Project: Graff Residence
3 Middle Patent Road
Tax ID: 95.03-1-52

Please see our responses to the RPRC Determination Letter, dated 9/22/20 for the Graff Residence.

PRELIMINARY SITE PLAN
FOR
THE GRAFF RESIDENCE
ARMONK, NY

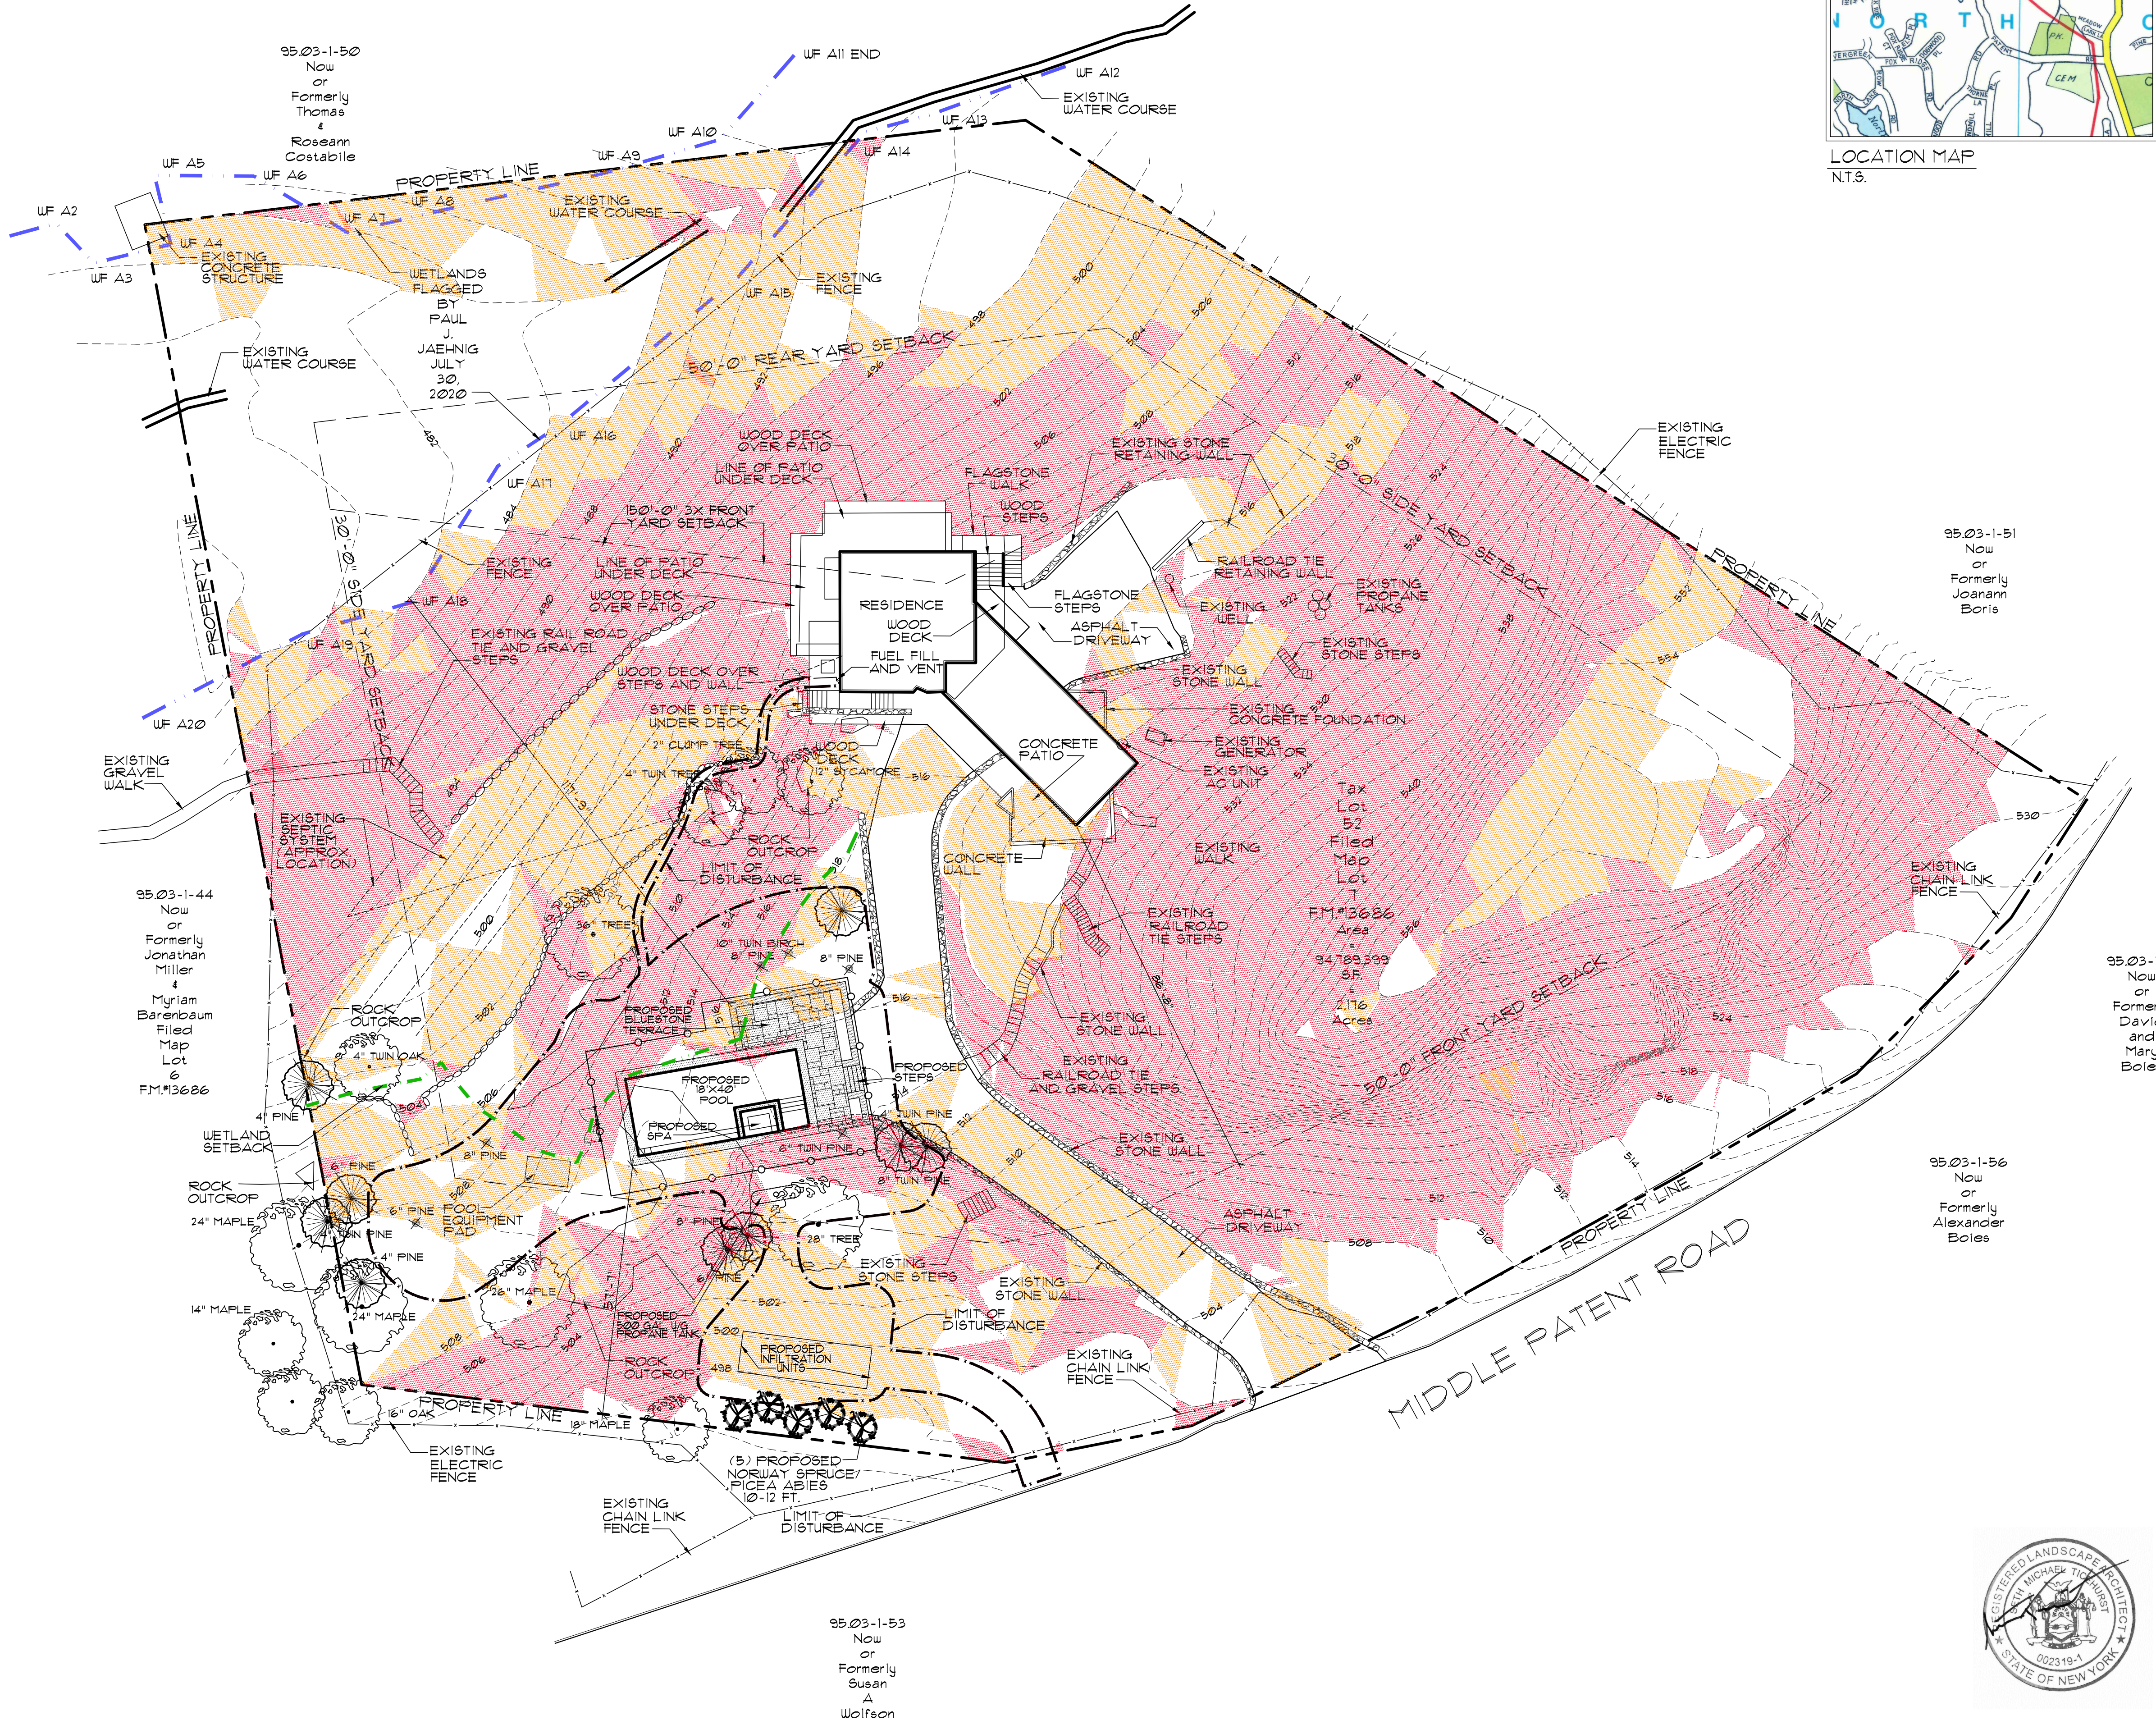
1. The Site Plan has been revised to contain a Zoning Compliance Chart.
2. Even though the proposed swimming pool is located in the front yard and does not meet the required 150' front yard setback, we believe that the proposed location is the most appropriate for the property considering the many challenges of the site. The pool will not be visible from the road due to the change in elevation and evergreen screening.

10. A note has been added to the Site plan that states "The construction of all walls greater than four (4) feet in height, shall be certified by the Design Professional, prior to issuance of a Certificate of Occupancy.

PRELIMINARY POOL LOCATION PLAN
FOR
THE GRAFF RESIDENCE
3 MIDDLE PATENT ROAD
ARMONK, NY

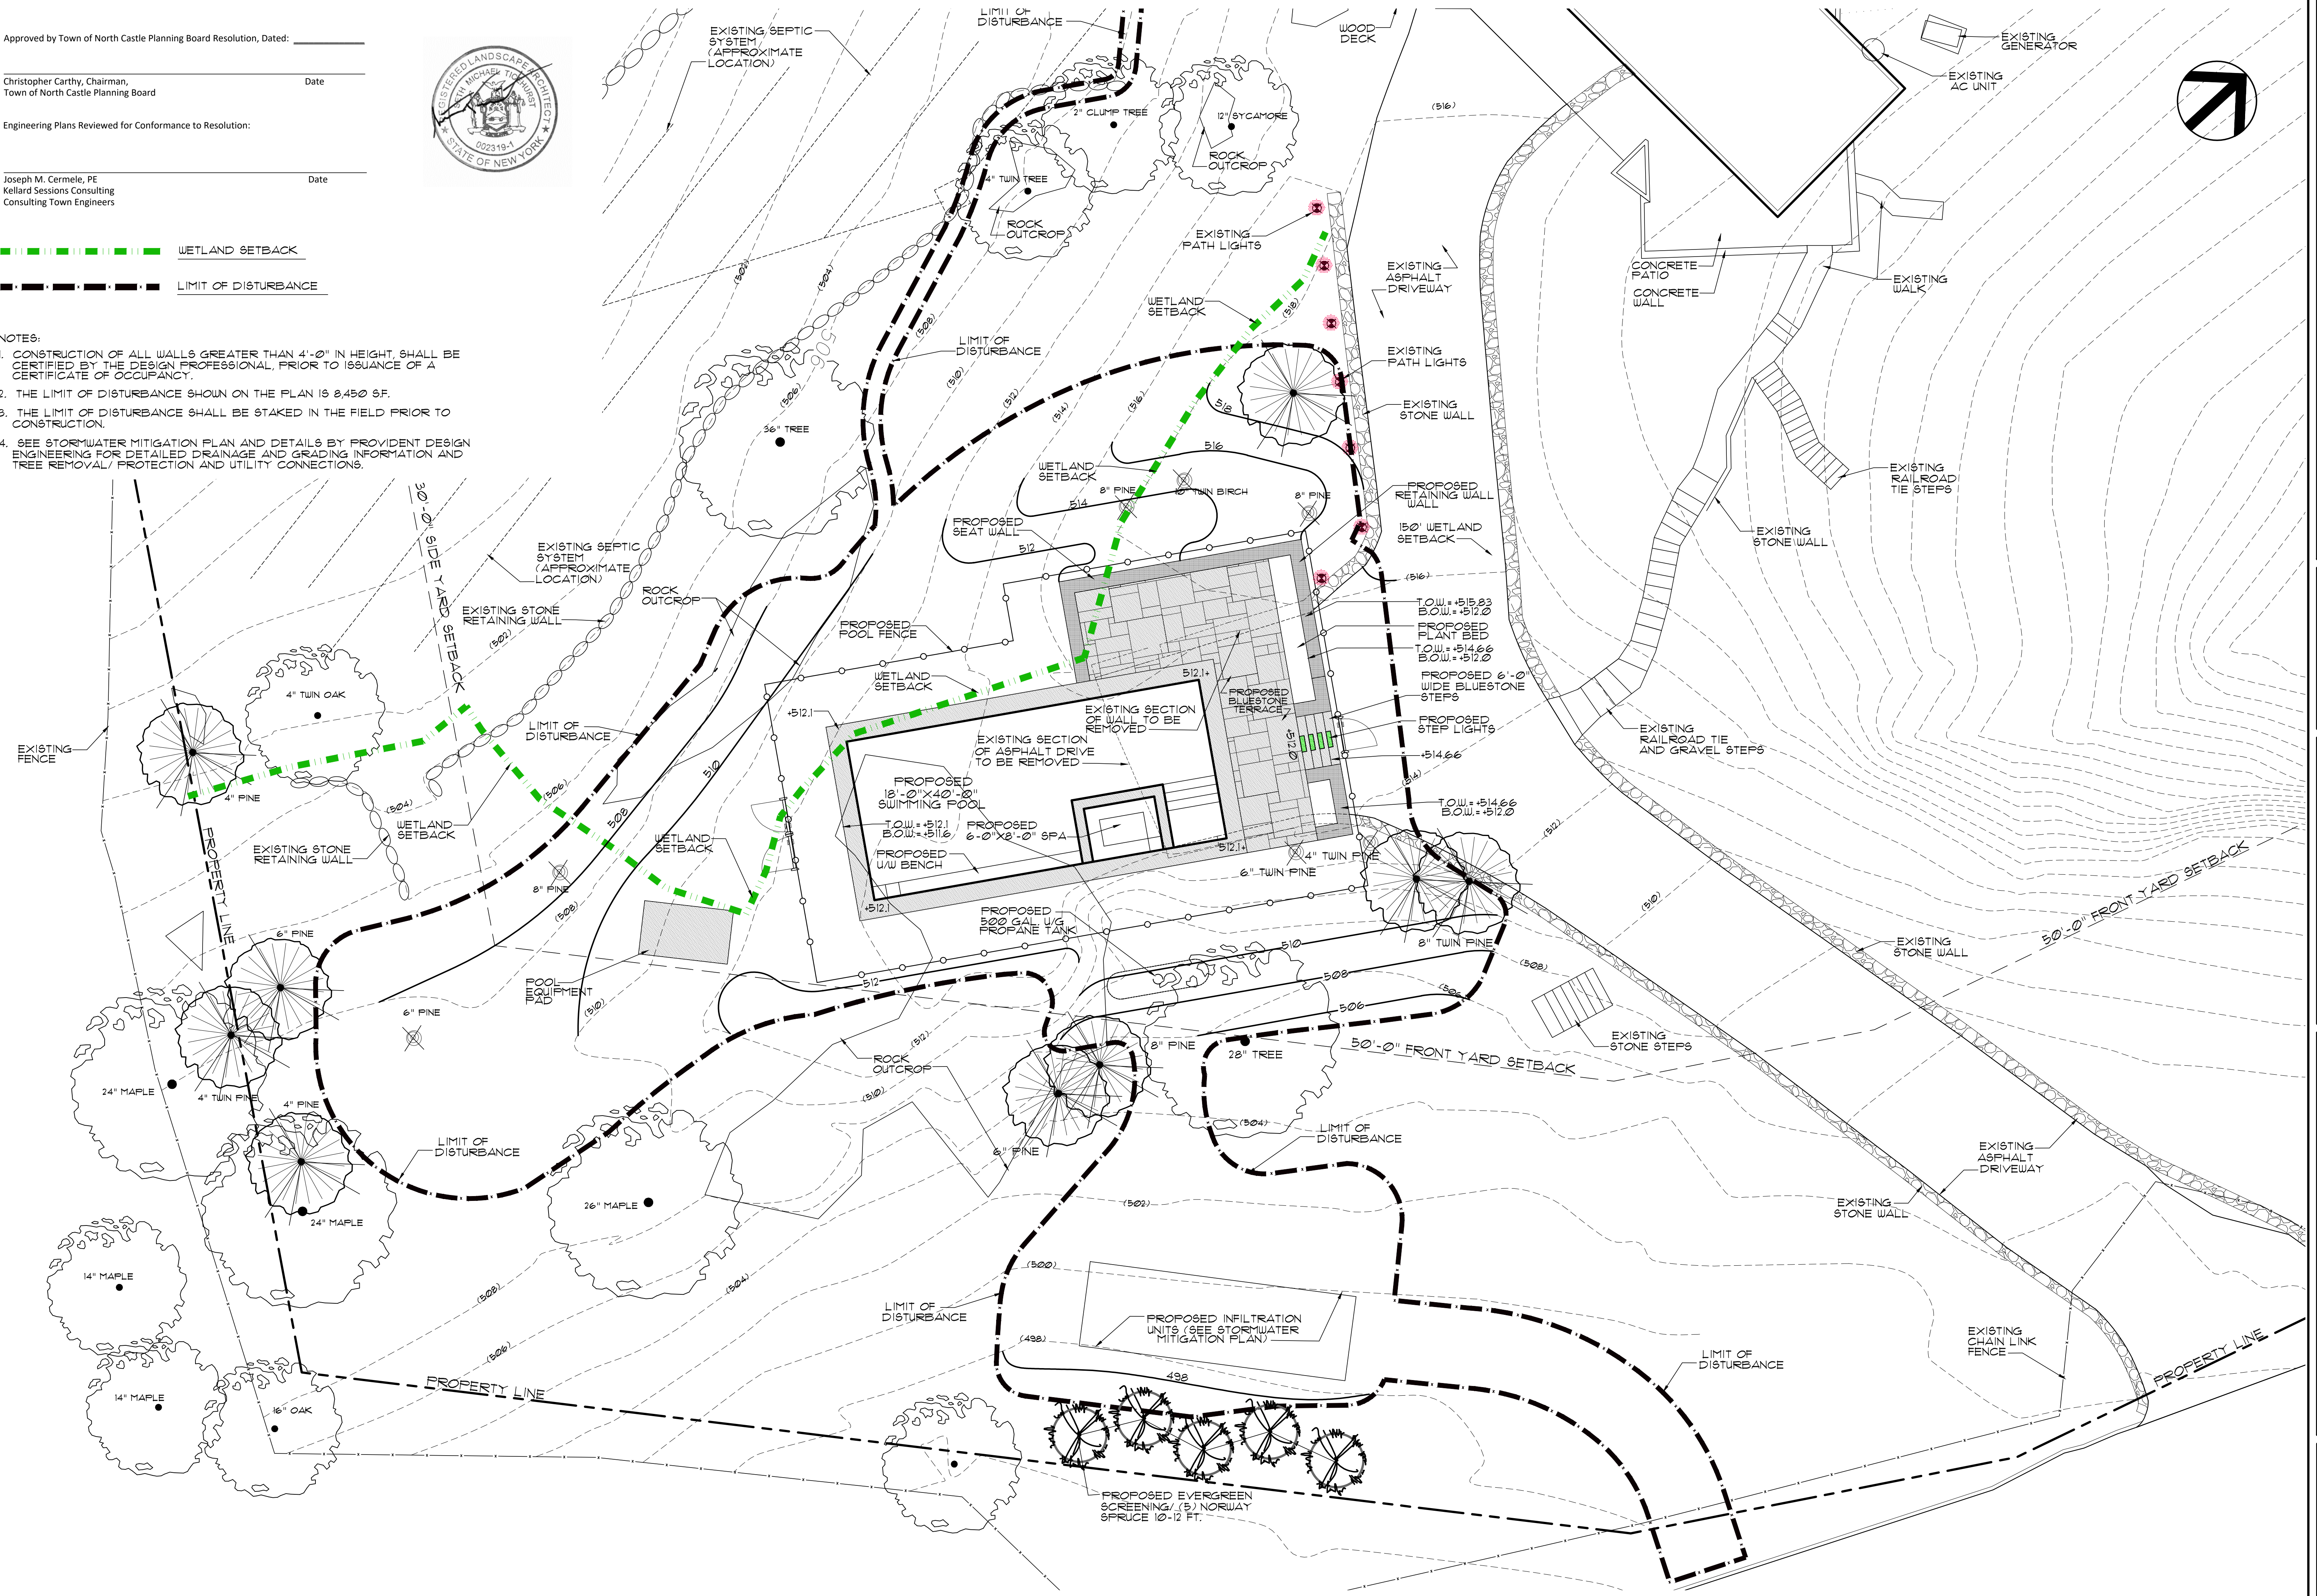
9. Spot grades are provided on the Preliminary Pool Location Plan to illustrate the top and bottom of wall elevations.

WETLAND MITIGATION PLAN

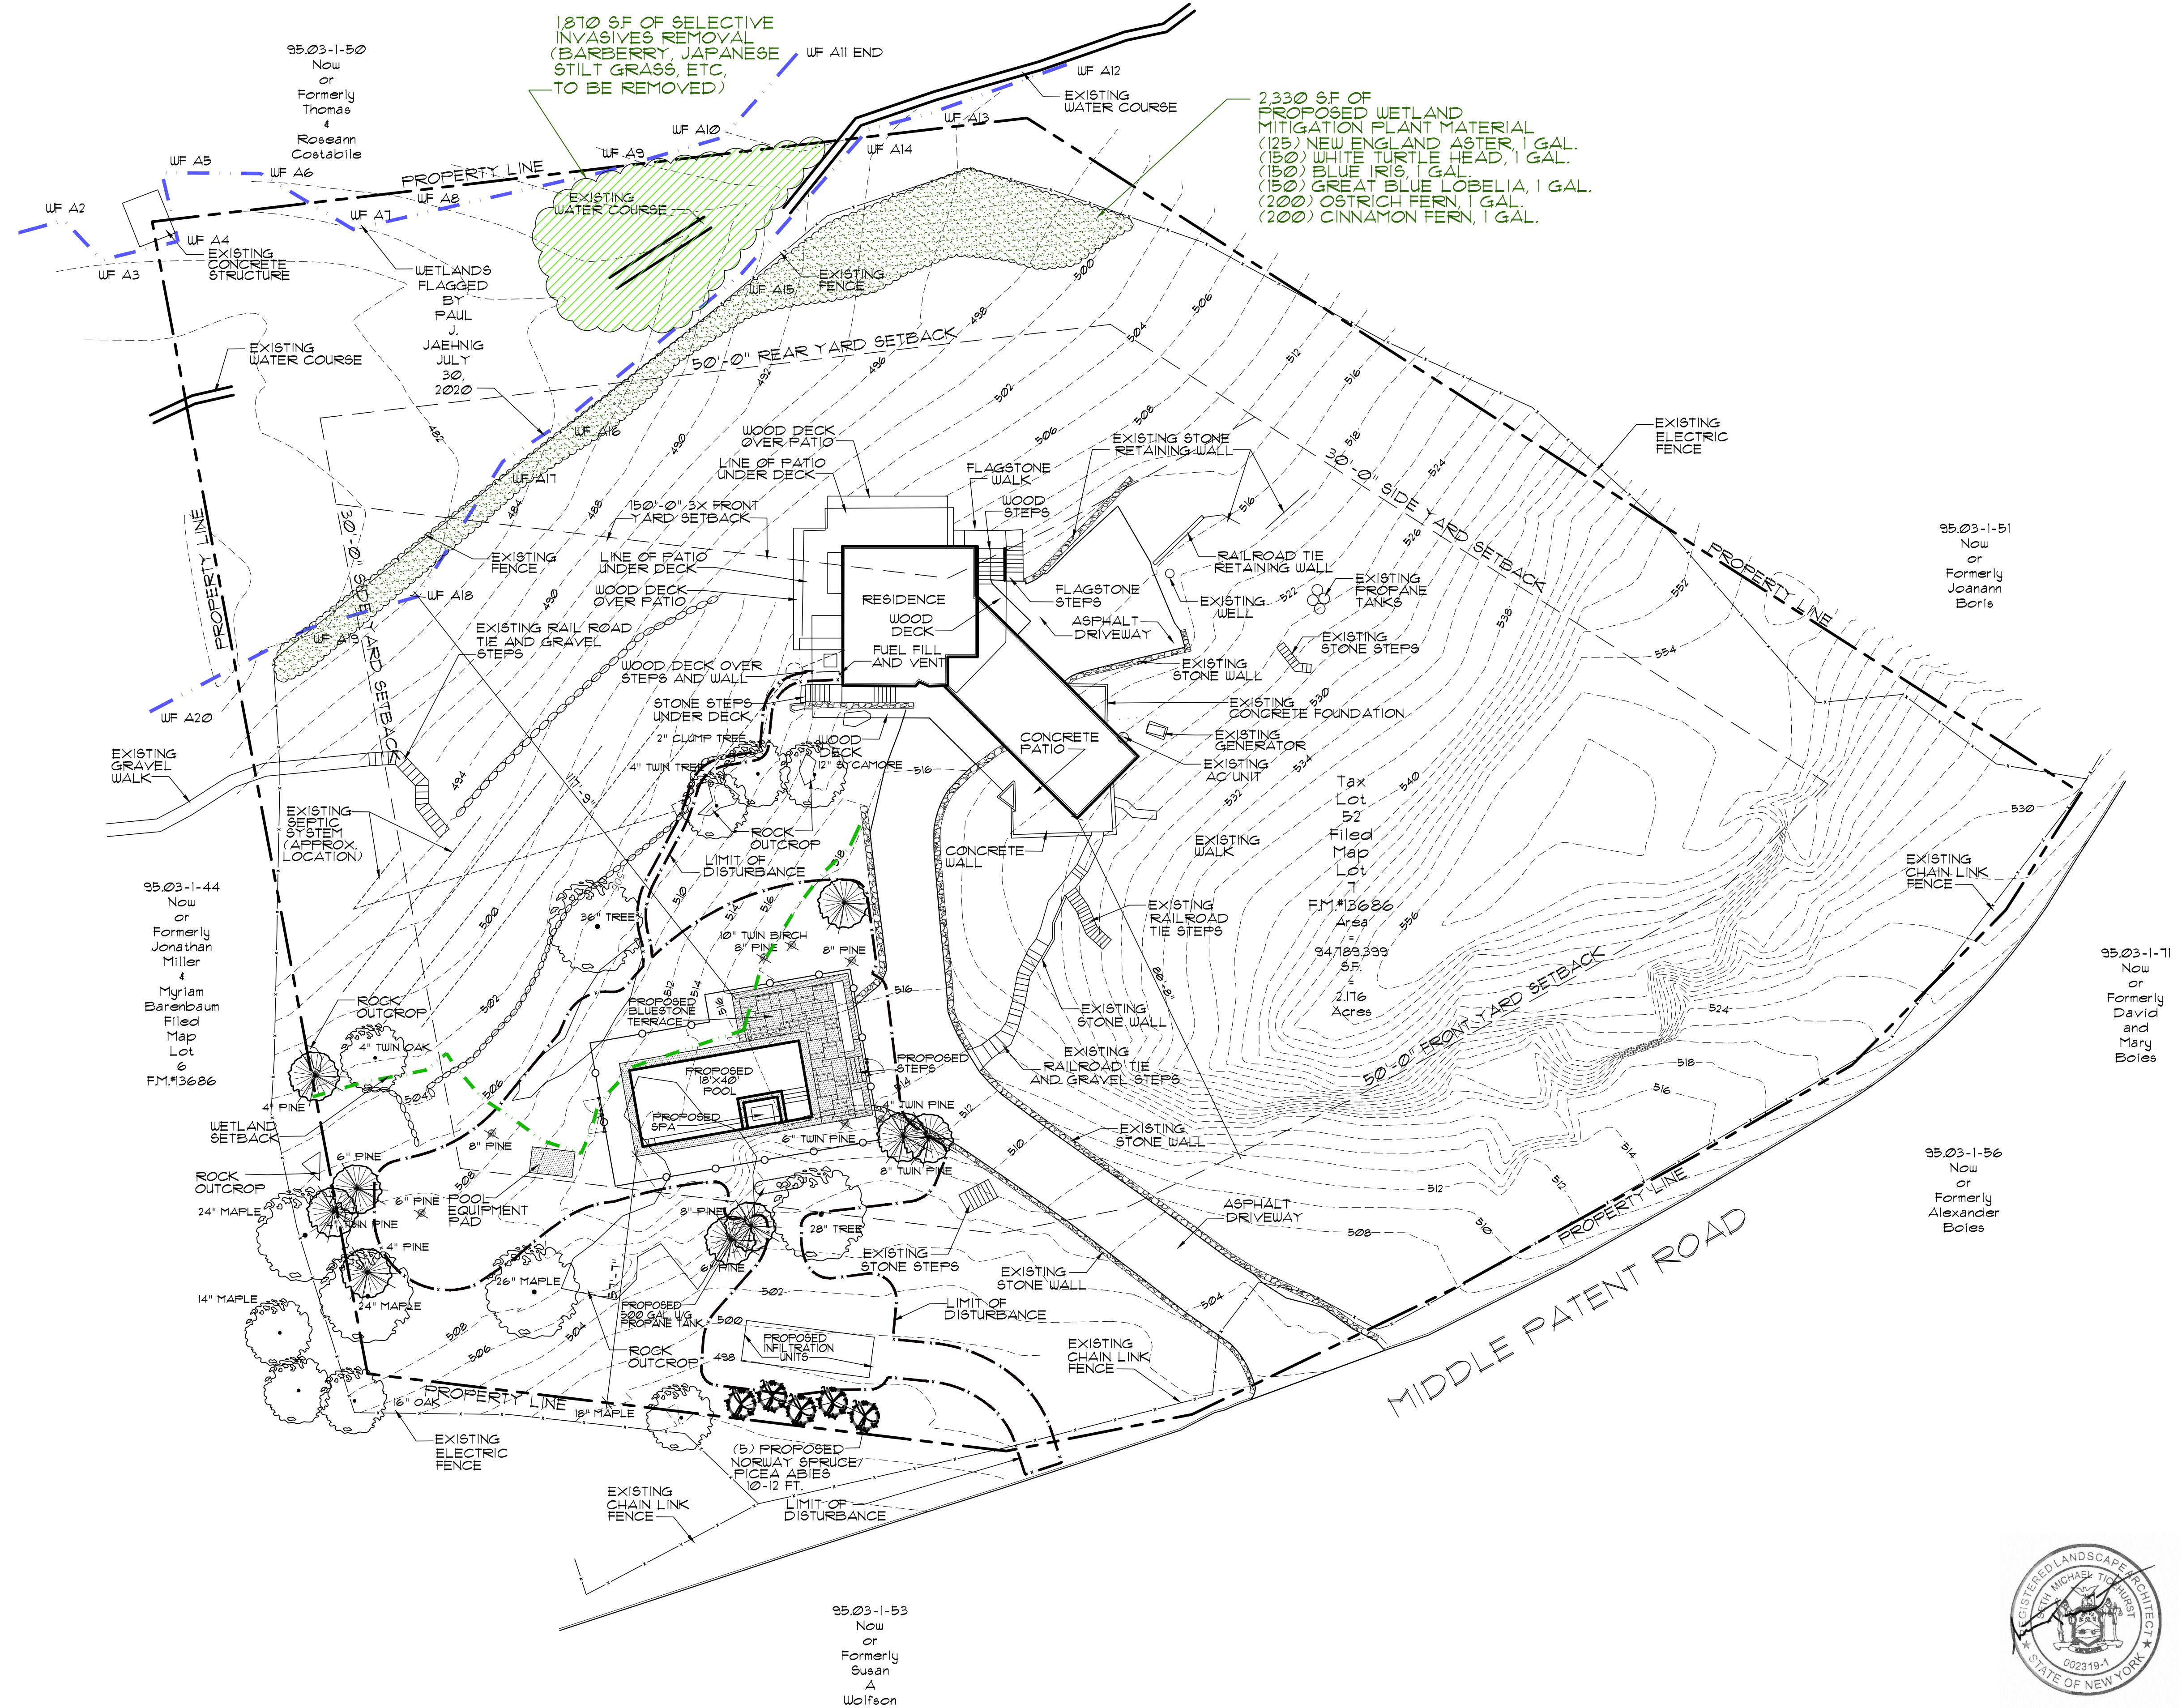
3. 1,763 s.f. of town regulated wetland buffer disturbance will occur due to the construction of the proposed improvements. A wetland mitigation plan that exceeds the 2:1 mitigation ratio has been provided.
